# Access Compliance Report

## Public Rights-of-Way

| Intersection ID: 42803                  | Main Street: BACK_ACRE_DR | Cross Street: SAWMILL_TRACE_DR          | Location: NE           |
| ADA ID: BC2D932EEE21                    | Ramp Type: PerpDiag       | Initial Pass/Fail: Fail                 | Overall Compliance: No |

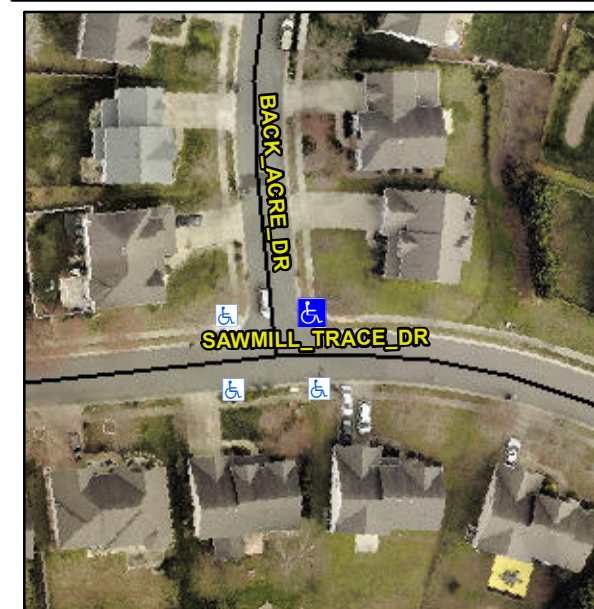
**Not Found, R304.5.1**

| Compliance | Description           | Data | Compliance | Description                 | Data |
|------------|-----------------------|------|------------|-----------------------------|------|
| No         | Ramp Width (in)       | 47.5 | Yes        | Ramp XSlope (%)             | 1.7  |

**Remove & Replace Curb Ramp With Two New Directional Ramps or Equivalent.**
